Revision	Description	Date
A	Initial Release	?
B	As built changes: E990211-00-C	5/99
C	1. Added compensation networks to coil drivers with capacitors, Cadd1 through Cadd10 and resistors Radd1 through Radd5 2. Changed coil driver 183 ohm (R202, R216, R229, R243, R256) to 125 ohm, 2 Watt for ITMX and ITMY and to 183 ohm 1 watt on all other chassis. 3. Cadd1 through Cadd14 added to board to stabilize and limit high freq gain of 1Hz zero, 40Hz pole compensation stage. 4. Dadd1 through Dadd20 added to coil driver for op amp input protection.	2/00
D	Added Radd6, Radd7, Radd8, Radd9 to terminate unused inputs of MAX333 switches per E010178-00.	10/01
D1	Removed two stages of chebychev filter for each degree of freedom per E010181-00.	10/01

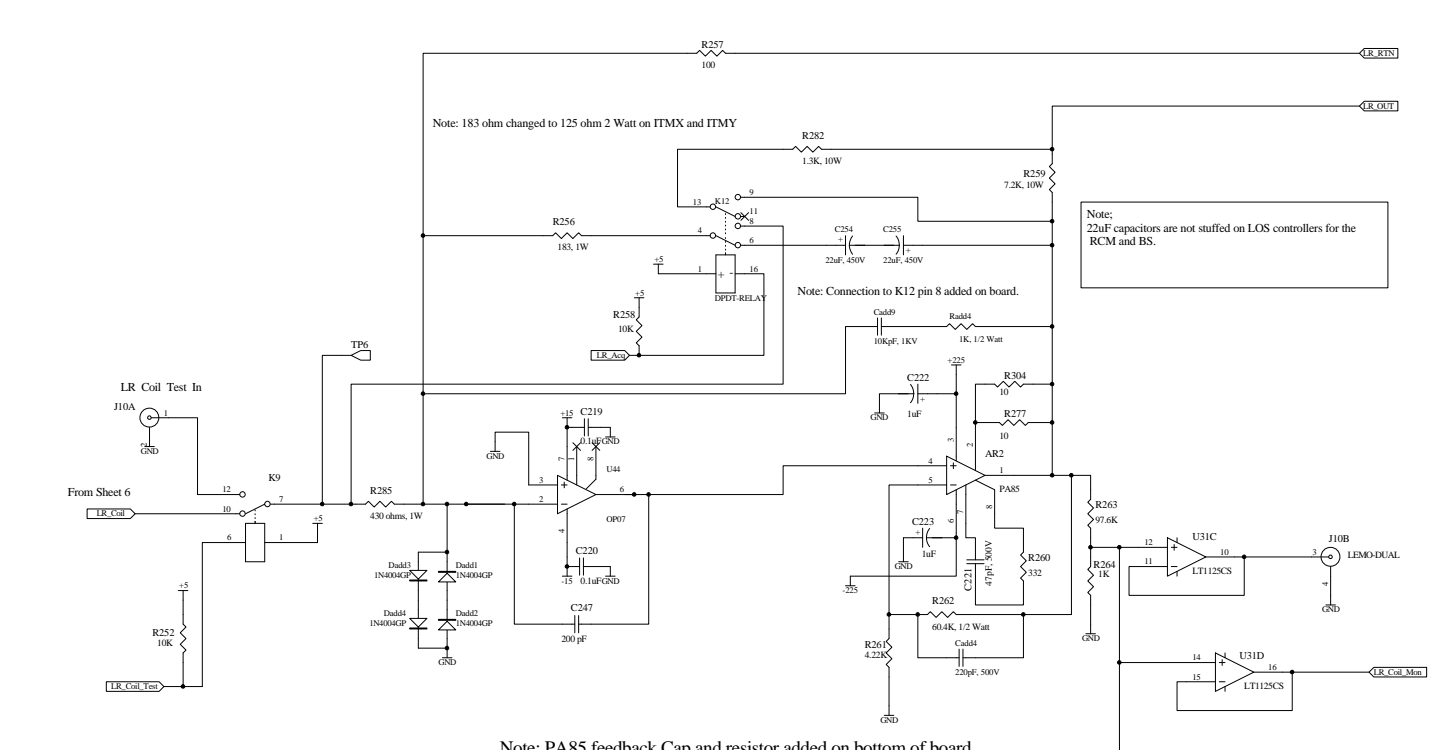
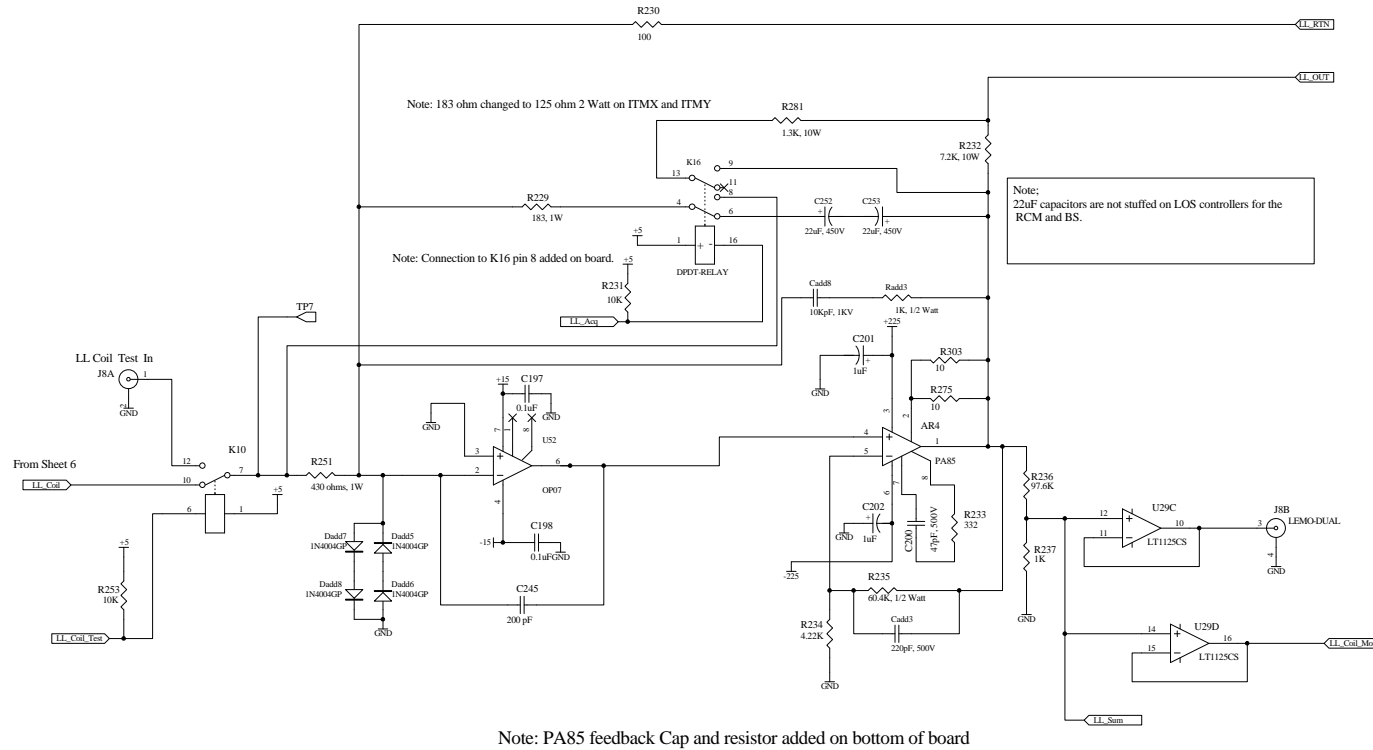
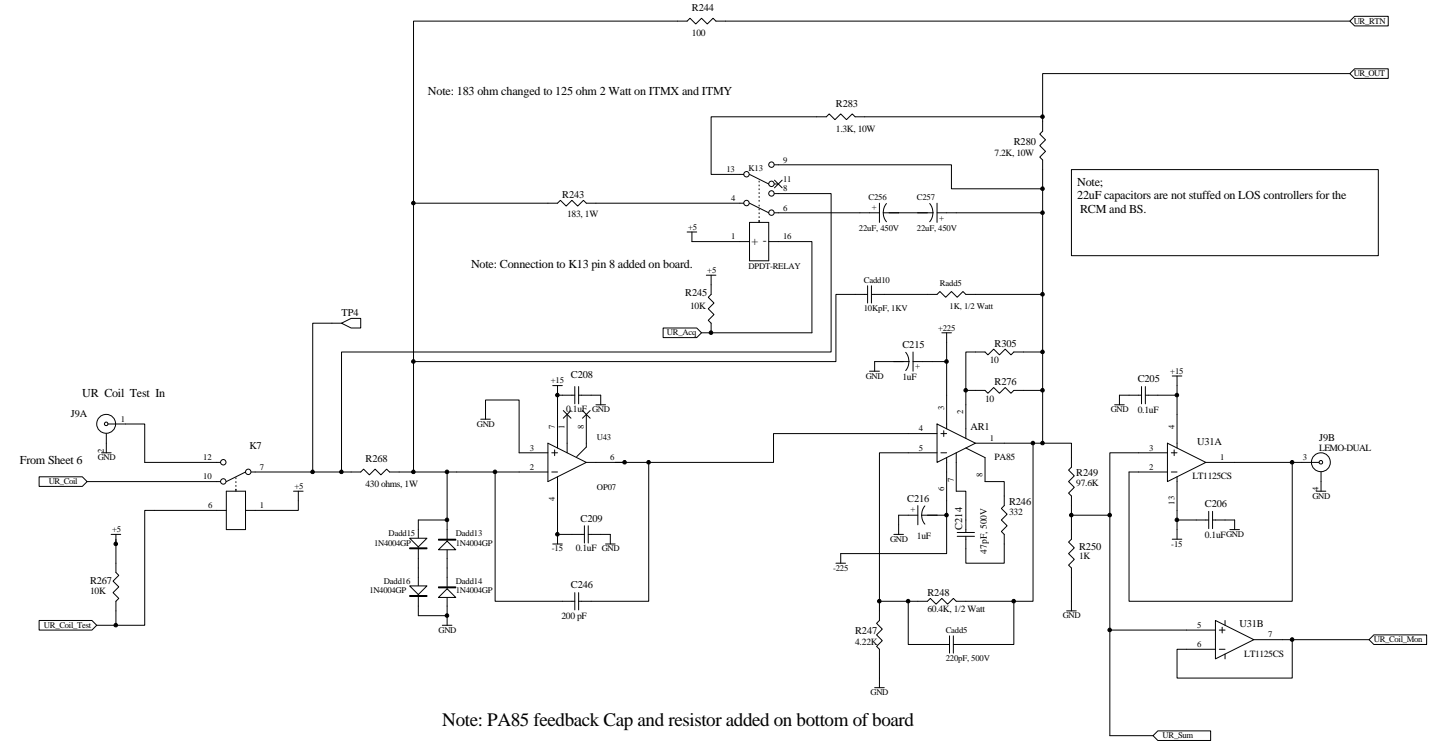
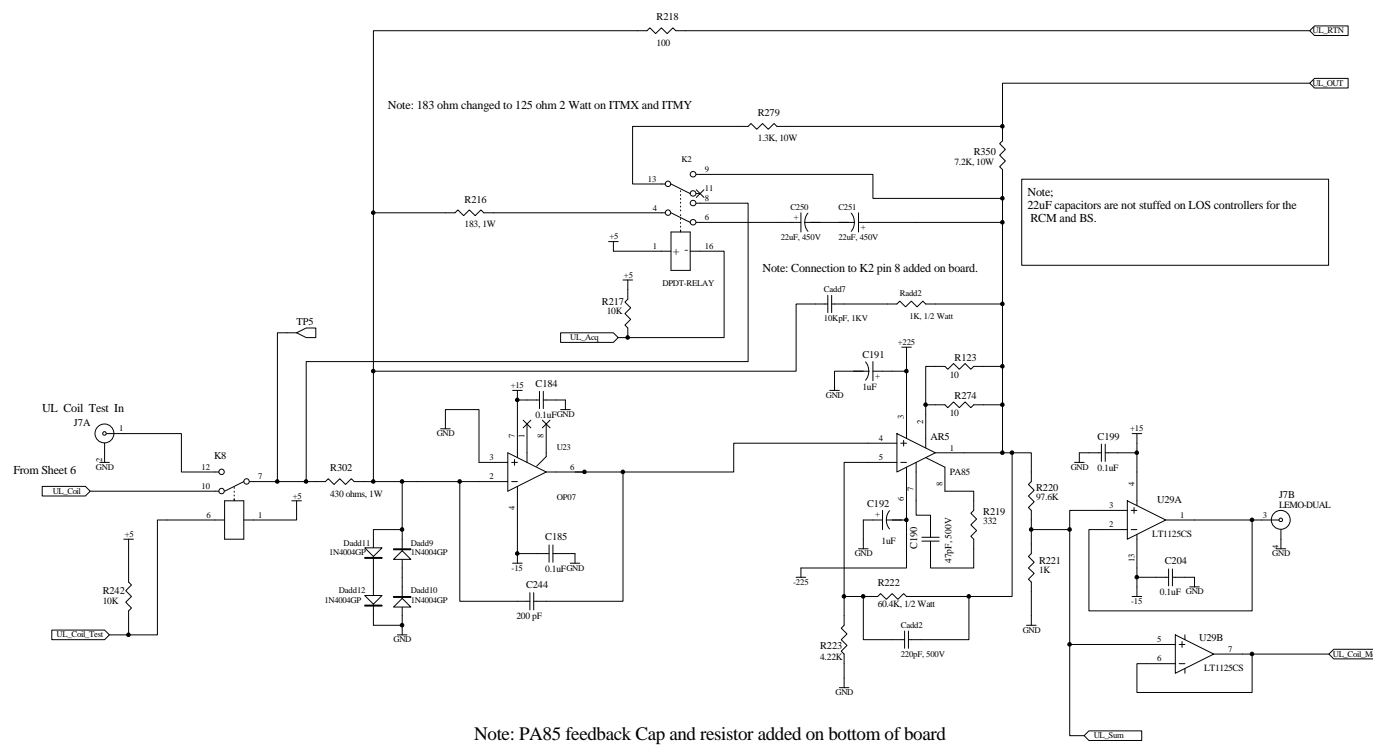
Wire added on board per Rev D1

Note: PA85 feedback Cap and resistor added on bottom of board

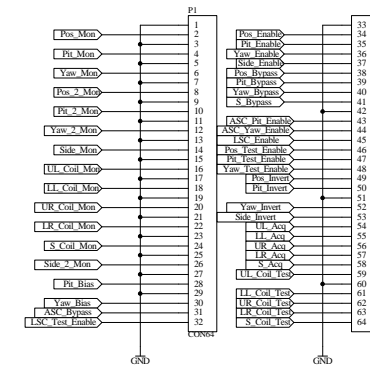
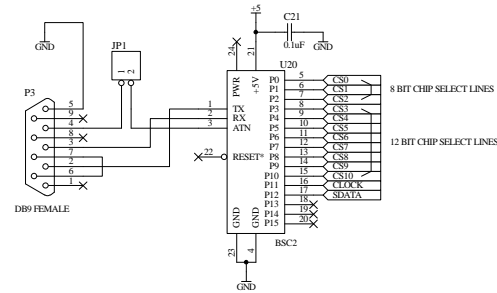
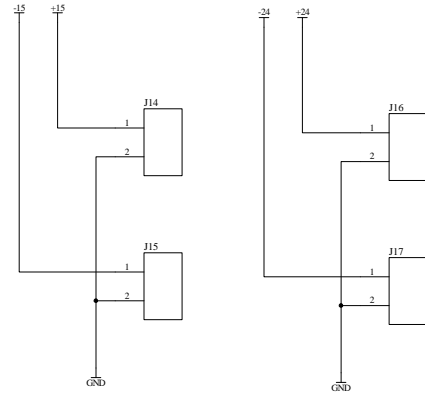
Note:
The wiring to the daughter card was changed after board manufacture. The actual connections to the board are made via wires to the coil driver outputs. The PD connections remain as shown.
An interface board (ref. D990022) is used for this function.
